A G E N D A
LOCAL PLANNING AGENCY / PLANNING ADVISORY BOARD
TO BE HELD MARCH 11, 2021
AT 5:30 PM
121 SW FLAGLER AVENUE, STUART FL 34994
121 S.W. FLAGLER AVE. STUART, FLORIDA 34994

1. PALMETTO COVE RPUD - REZONING TO RPUD (QUASI-JUDICIAL)(RC):

SITE DEVELOPMENT PLANS
PALMETTO COVE
502 Halpatiokee Street & 924 SW Palm City Road, Stuart, Florida

CITY OF STUART
Local Planning Agency
 March 11, 2021

CONCEPTUAL ENGINEERING PLAN

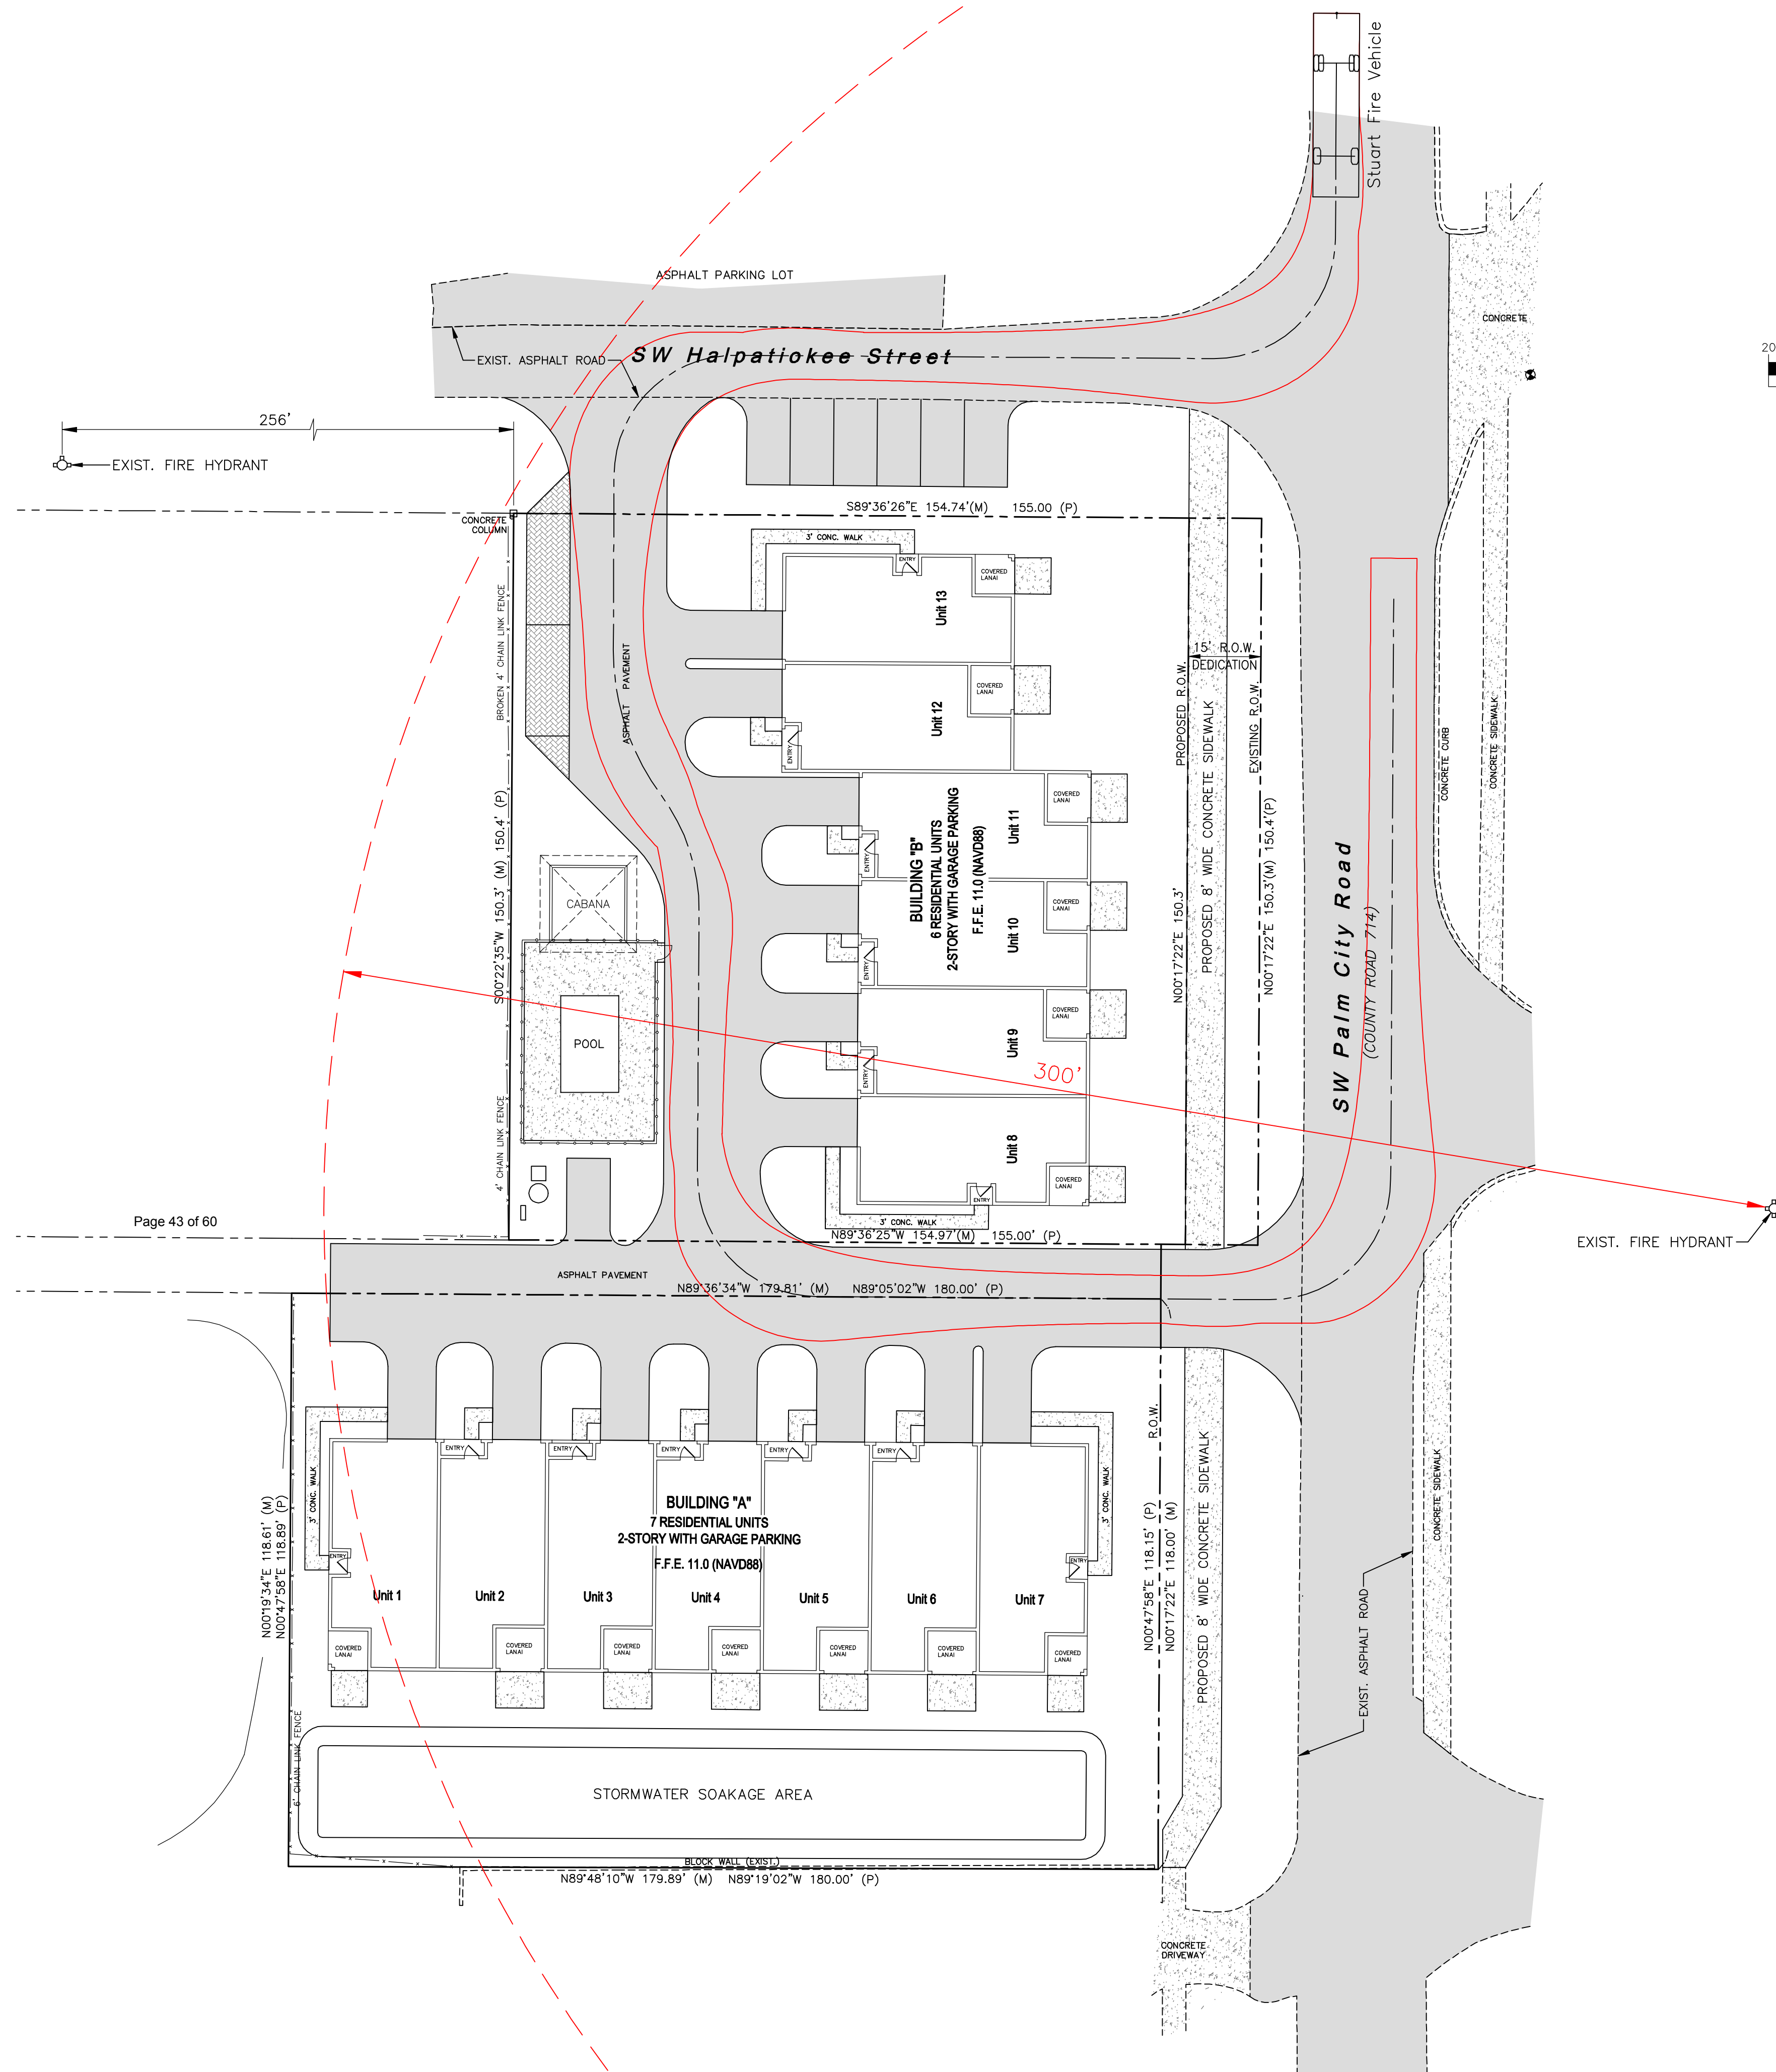
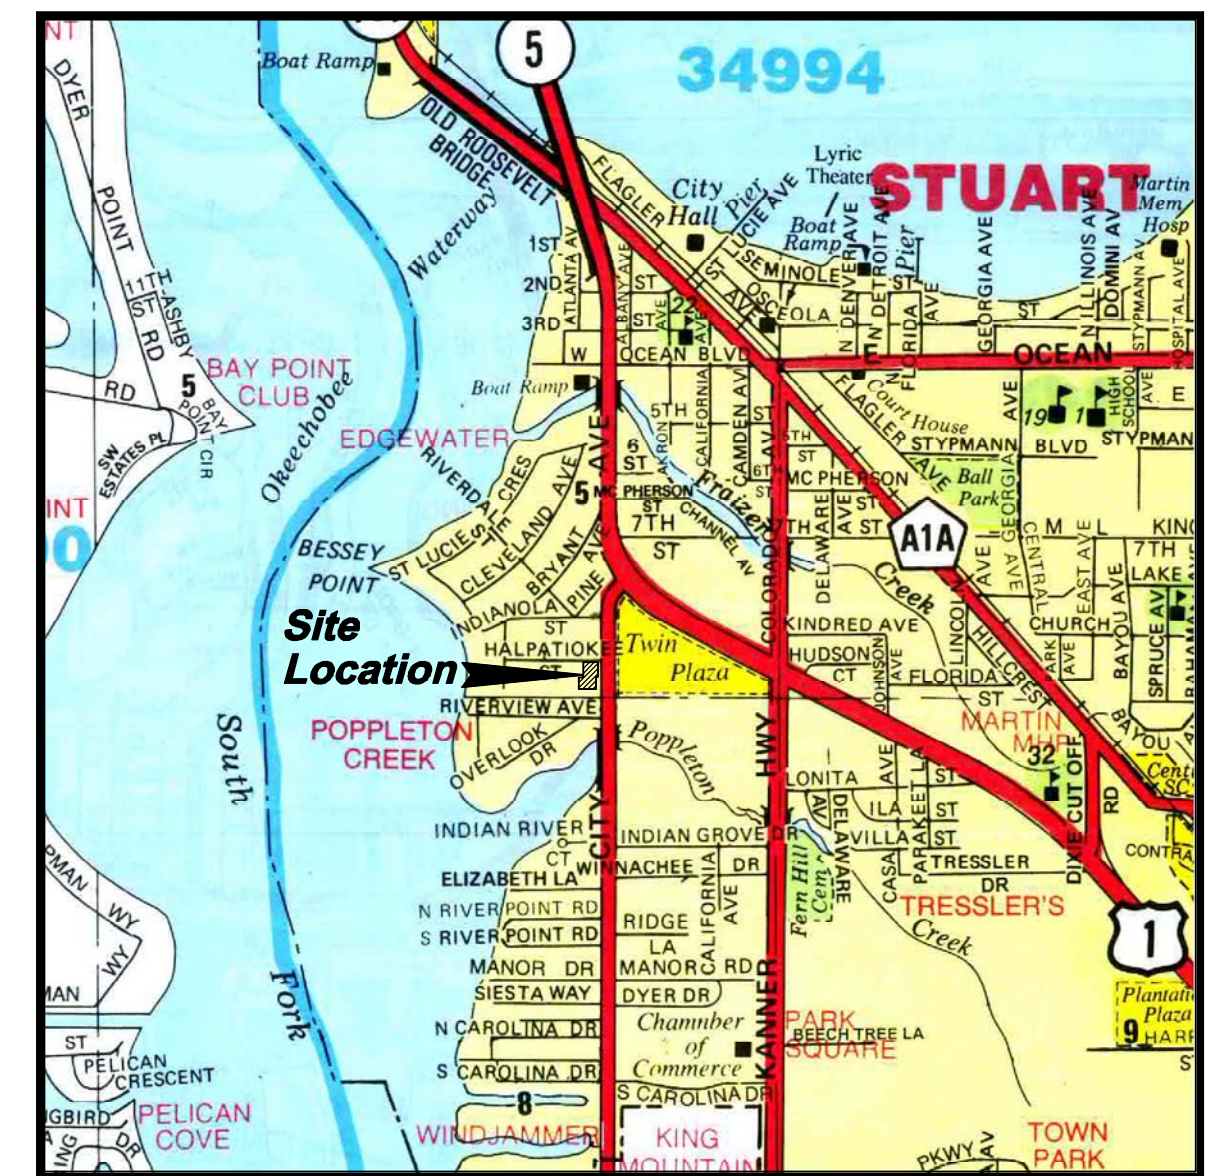
- 2) *NFPA 1, 18.2.3.4.3.1 The turning radius of a fire department access road shall be as approved by the AHJ. Submit Autoturn using Stuart Fire Rescue truck specifications. Contact mcawley@ci.stuart.fl.us for specification sheet.*

- 3) *Show location of fire hydrants.*

The drive aisle pavement width thru the Development has been revised on the Site Plan and Conceptual Engineering Plan to provide the minimum twenty (20) feet as requested.

The nearest existing fire hydrants are shown on the revised Site Plan and Conceptual Engineering Plan.

SANITATION TRUCK MANEUVERING EXHIBIT 1

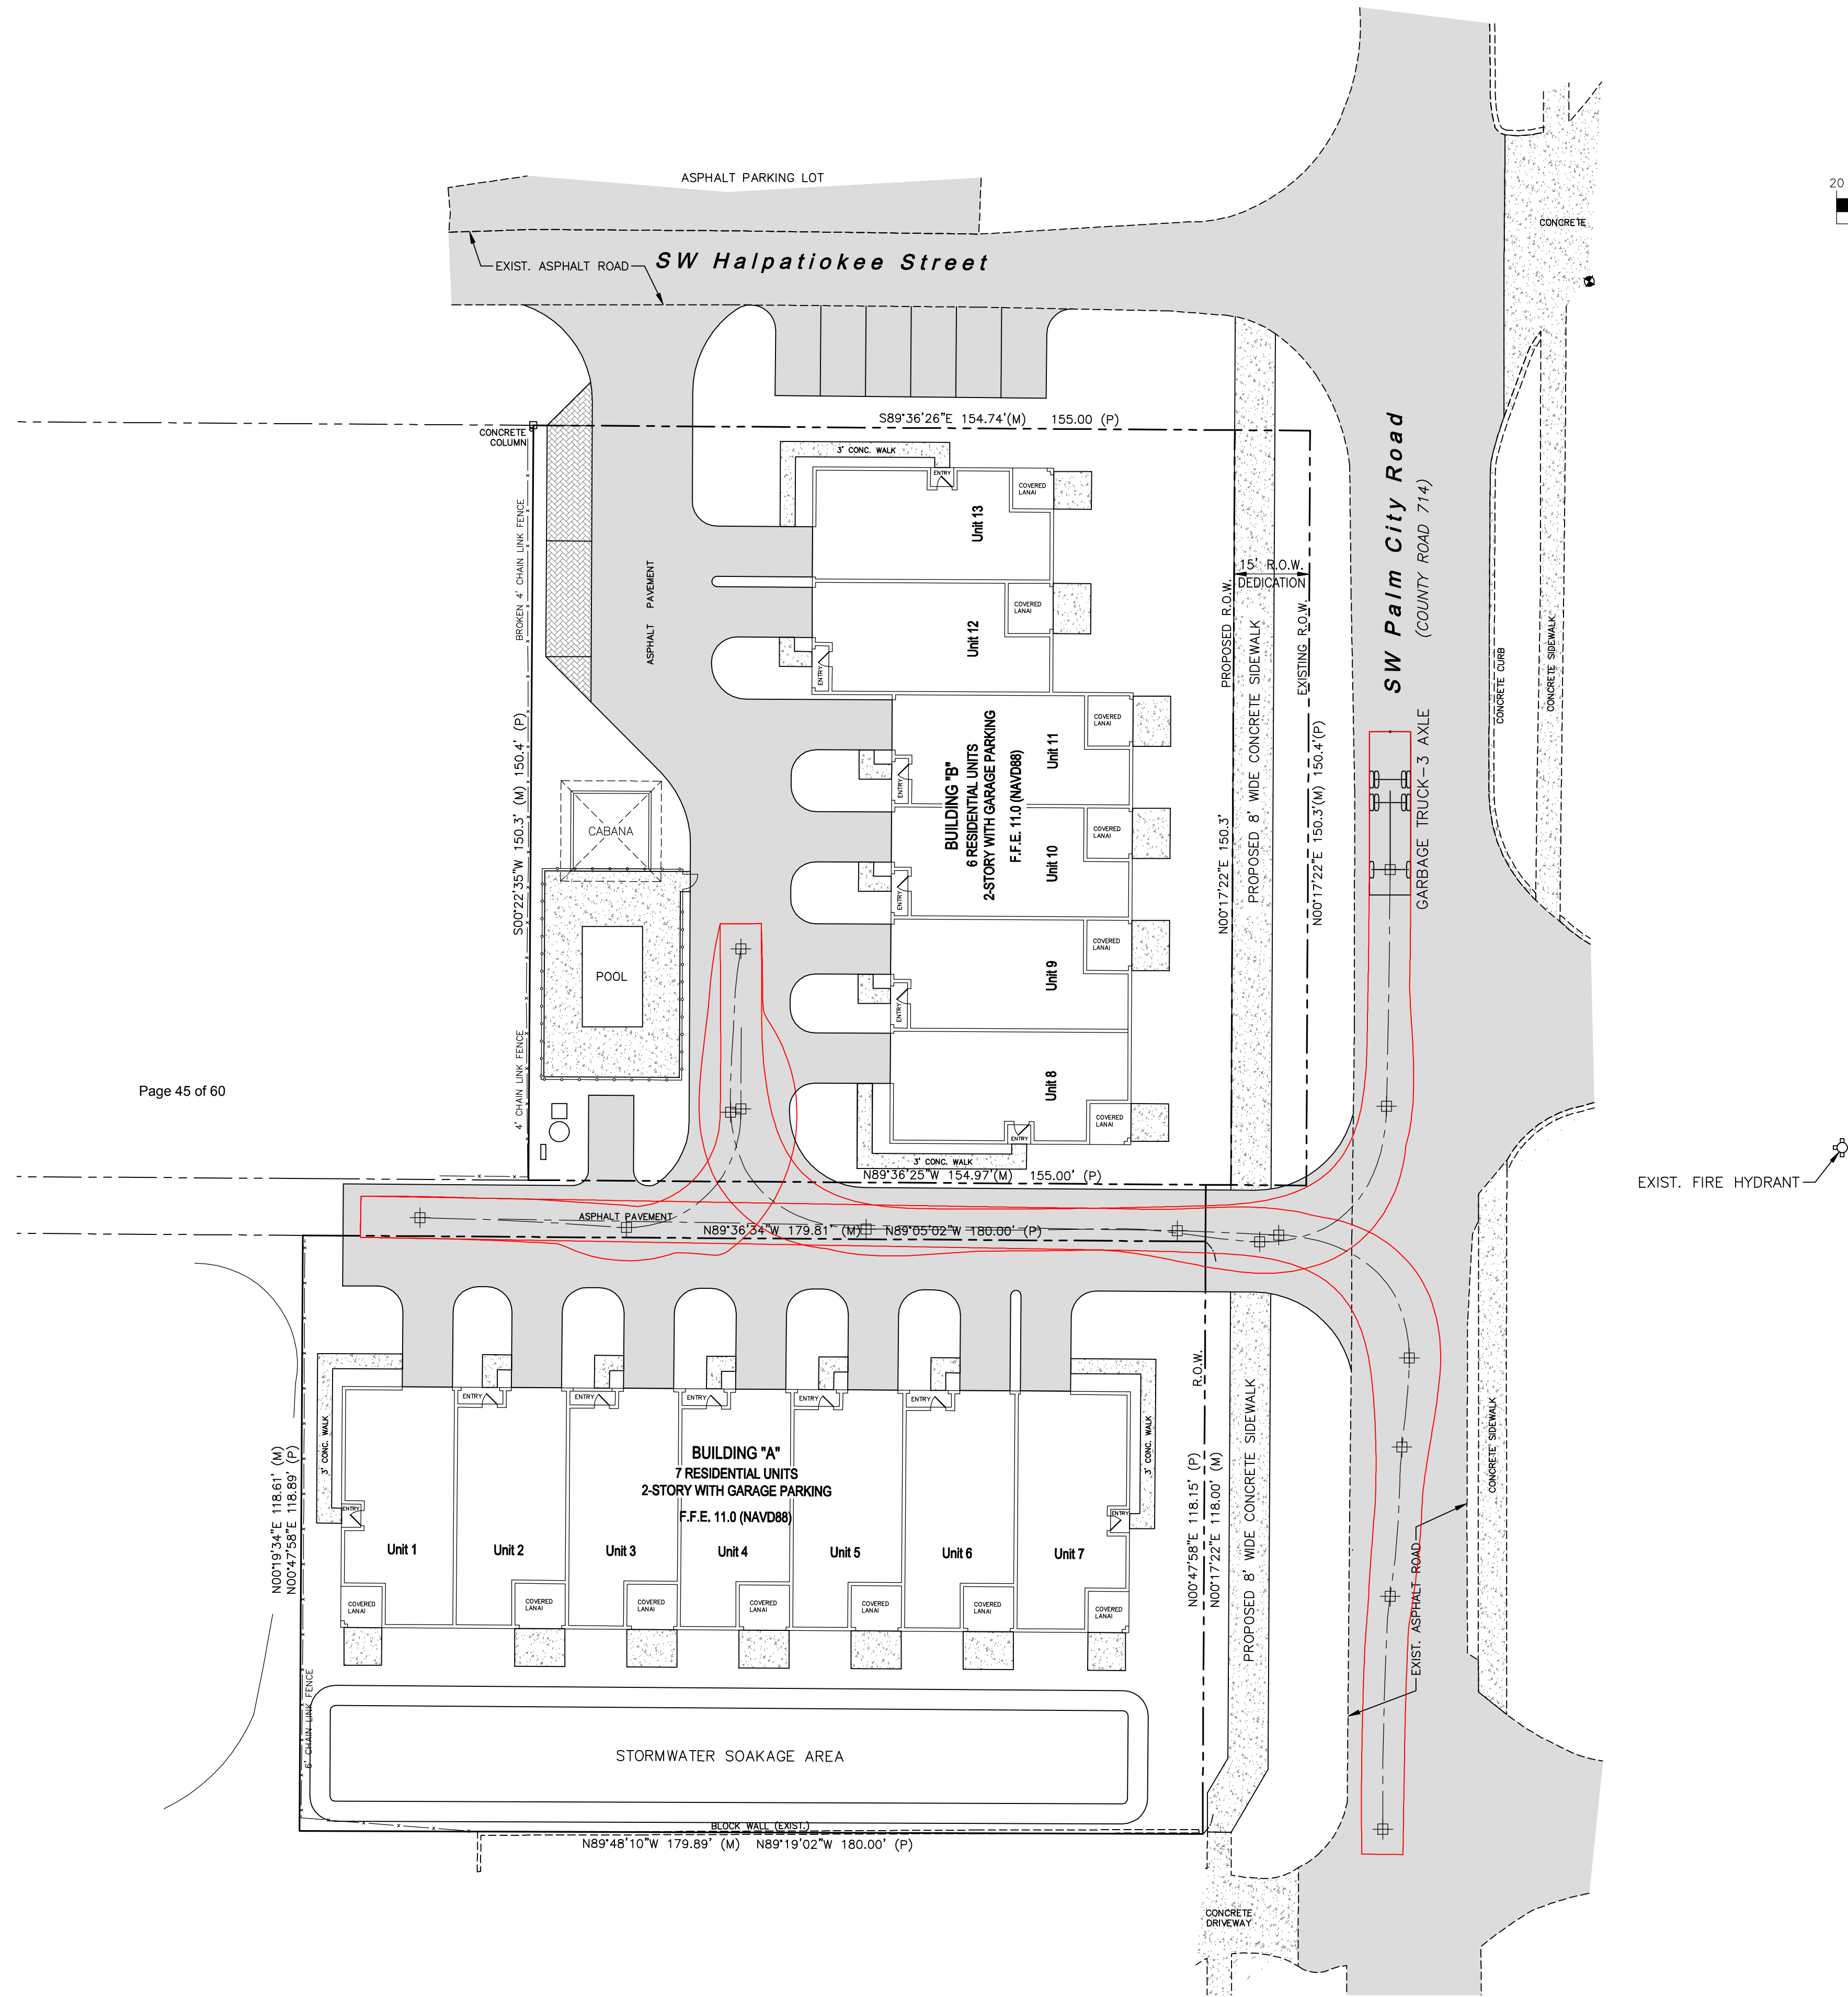
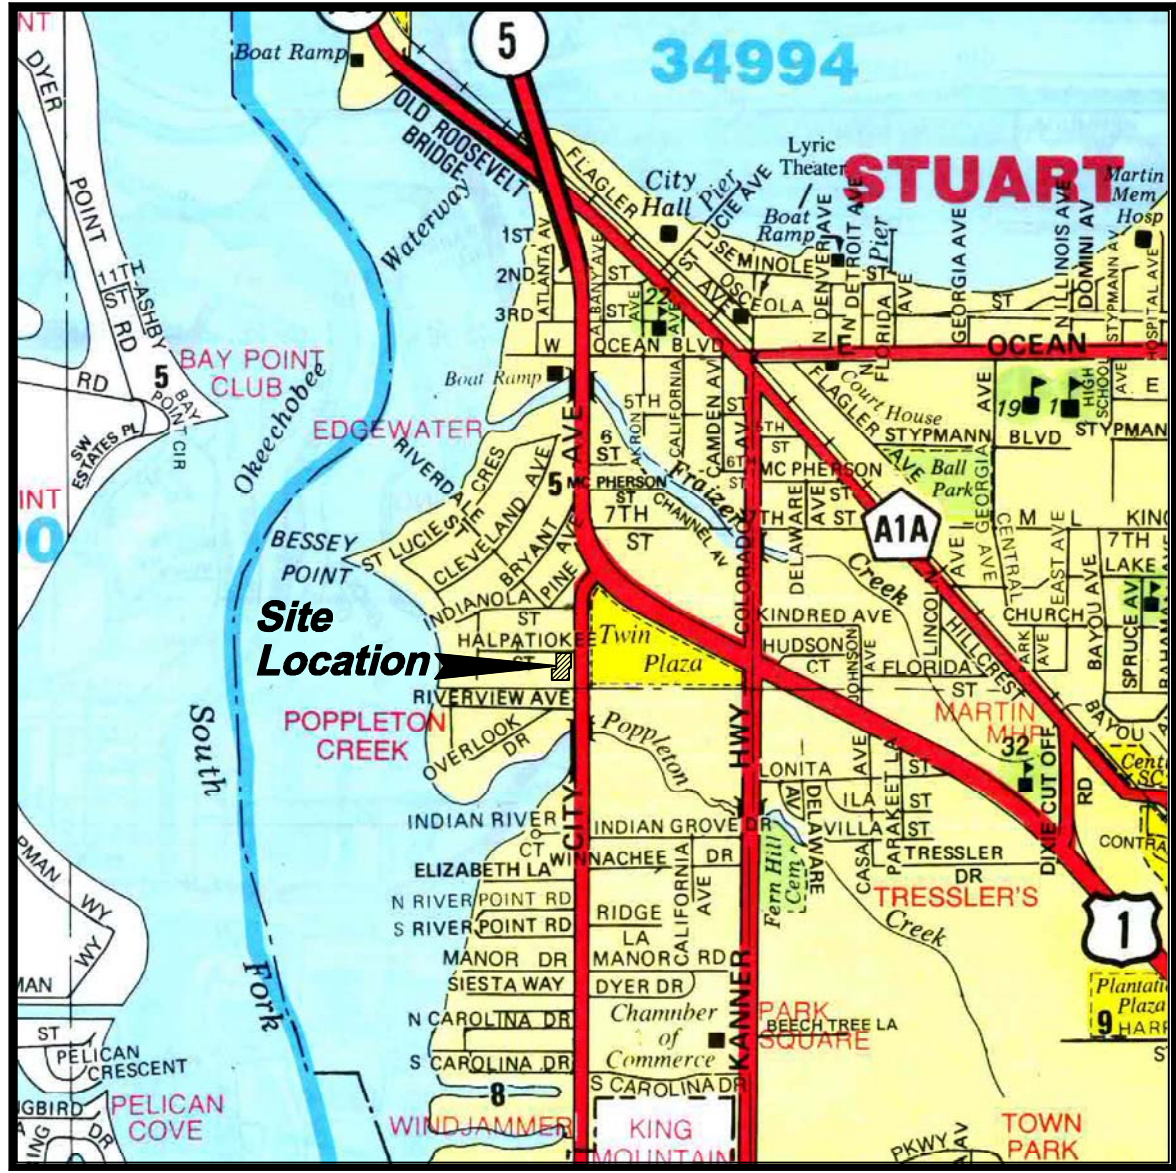
Applicant must provide an AutoTurn exhibit ensuring a 42 ft side loading (from passenger side) sanitation truck can service all carts safely with minimal backing.
